# Re: M2020007 Ragsdale Reservoirs Acreage Release AR1 Inspection Report

# MINERALS PROGRAM INSPECTION REPORT PHONE: (303) 866-3567

MINE NAME:	MINE/PROSPECTING ID#:	MINERAL:	COUNTY:
Ragsdale Reservoirs	M-2020-007	Gravel, sand and	Weld
		borrow material	
INSPECTION TYPE:	WEATHER: Clear	INSP. DATE:	INSP. TIME:
Surety Release Inspection		July 16, 2024	10:00
OPERATOR:	<b>OPERATOR REPRESENTATIVE:</b>	TYPE OF OPERAT	FION:
L. G. Everist, Incorporated	Lynn Mayer Schults	112c - Construction	Regular Operation

# CONSTRUCTION PLANS FOR **RAGSDALE UNDERDRAIN**

Image 2: Google Imagery showing the approximate permit boundary on the west side of the permit area and the location of the installed underdrain (blue line) between the Phase 1 and Phase 2 mining areas. Image dated 9/4/2023.

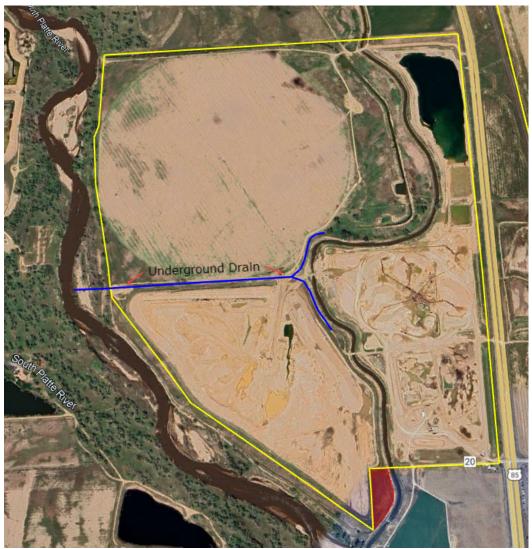
**POSSIBLE VIOLATION:** Possible Violation: The Division observed an underdrain that runs between the Phase 1 and Phase 2 mining areas. The drain was installed to move groundwater from the east around the slurry walled reservoirs and extends beyond the western permit boundary where it discharges to the South Platte River. Land was affected outside of the approved permit boundary for the installation of the drain. This is a possible violation at this time pursuant to C.R.S. 34-32.5-116(4)(i) for failure to protect areas outside of the affected land from slides or damages occurring during the mining operation.

Additionally, the Division observed the underdrain outlet in the South Platte River, which flows parallel to the western permit boundary. According to the description in the 2020 application, the western permit boundary is 100 feet east and parallel to the east toe of a historic levee/berm that was built by the landowner along the South Platte River. Based on this description and observations in the field, the Division determined the underdrain extends 400-feet beyond the western permit boundary to the South Platte River. The Division observed a 20-foot-wide x 400-foot-long disturbance patch between the western permit boundary and the discharge point. Concrete was placed at the culvert outlet to prevent erosion around the drain. Therefore, this section of the underdrain is outside the permitted area. Based on the observations during this inspection, approximately 8000 ft<sup>2</sup> (0.18 acre) was affected outside of the approved permit boundary for the installation of the underdrain. Pursuant to C.R.S. 34-32.5-116(4)(i) this is a possible violation for failure to protect areas outside of the affected land from slides or damages occurring during the mining. As cited above, this Possible Violation will require a hearing before the Mined Land Reclamation Board. The schedule and other details for the MLRB hearing will be provided under a separate document to be sent via certified mail to the operator.

Based on the observations during this inspection and the schematics and plans provided, LGE will need to submit an Amendment Application and obtain approval for the underdrain and extend the permit boundary to encompass the area affected by the installation and operation of the drain.

**CORRECTIVE ACTIONS:** This possible violation will require a hearing before the Mined Land Reclamation Board. The schedule and other details for the MLRB hearing will be provided under a separate document to be sent via certified mail to the operator.
